JOINT REGIONAL PLANNING PANEL (Sydney East Region)

JRPP No	2015SYE042
DA Number	DA-2014/346/A
Local Government Area	ROCKDALE CITY COUNCIL
Proposed Development	Section 96(2) Modification to development consent No.DA-2014/346 including the addition of five (5) units totalling 83 units and changes to the building height
Street Address	2-8 Loftus Street & 1- 3 Edward Street, TURRELLA NSW 2205 Lots 24-27 and Lots 31-34 in DP 4274
Applicant/Owner	Benson McCormack Pty Ltd
Number of Submissions	Four (4) submissions from four (4) property addresses
Regional Development Criteria (Schedule 4A of the Act)	The proposal is a Section 96(2) Modification to a development application that has a capital investment value of more than \$20 million.
List of All Relevant s79C(1)(a) Matters	• List all of the relevant environmental planning instruments: s79C(1)(a)(i) - <i>State Environmental Planning Policy Building Sustainability Index (BASIX)</i> - <i>State Environmental Planning Policy No.55 - Contaminated Land (SEPP 55)</i> - <i>State Environmental Planning Policy (Infrastructure) 2007</i> - <i>State Environmental Planning Policy No.65 - Design Quality of Residential Flat Development (SEPP 65)</i> - <

Figure 3. Proposed east elevation along Loftus Street. The proposed modification is the floor level shown above the 18m building height line and within the 'red bubble cloud'.
Source: Benson McCormack Architects

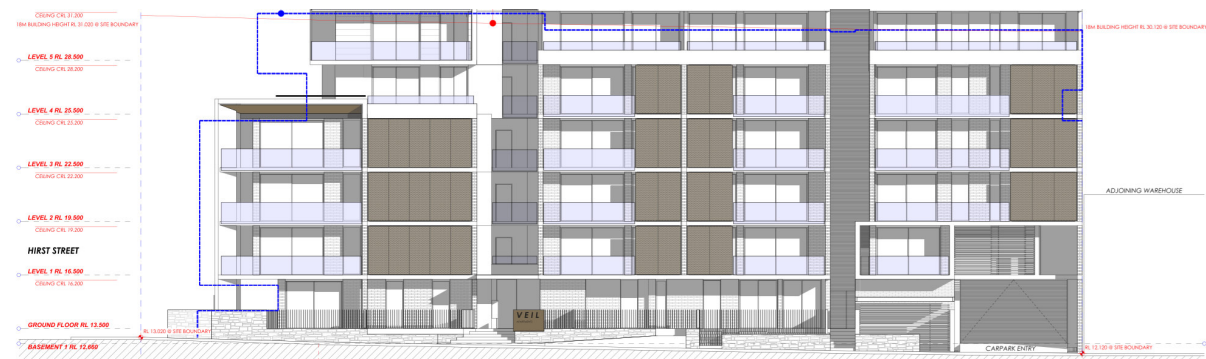
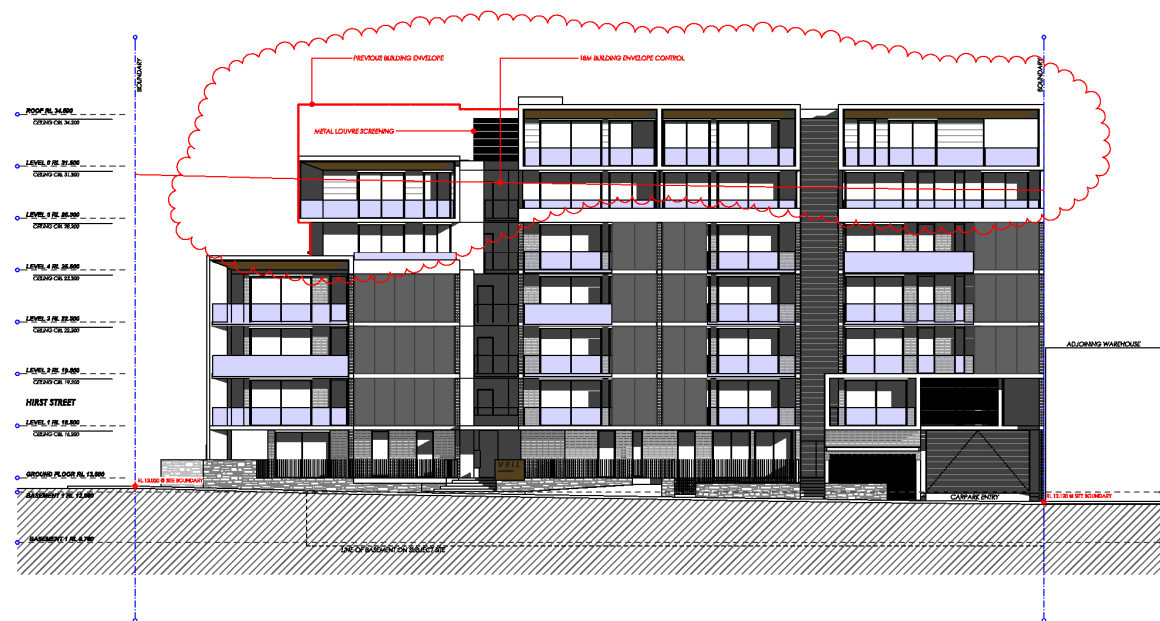
The approved scheme granted consent to a building height of approximately 19.38-19.77 metres along Loftus Street, which exceeded the maximum 18 metre building height by 1.38-1.77 metres. The proposed modification seeks a building height (top of concrete roof) of approximately 22.38-22.77 metres along Loftus Street, which exceeds the maximum 18 metre building height by 4.38-4.77 metres.

The applicant's justification is not supported as the additional building height sought seeks a building height of 4.38-4.77 metres above the maximum 18m building height control, which is inconsistent with the advice from DRP, is not considered to be compatible with the existing and future streetscape and will not assist in a transitional built form from a high density residential area to a low density residential area to the north. In addition the proposed additional height will set an undesirable precedent for similar developments.
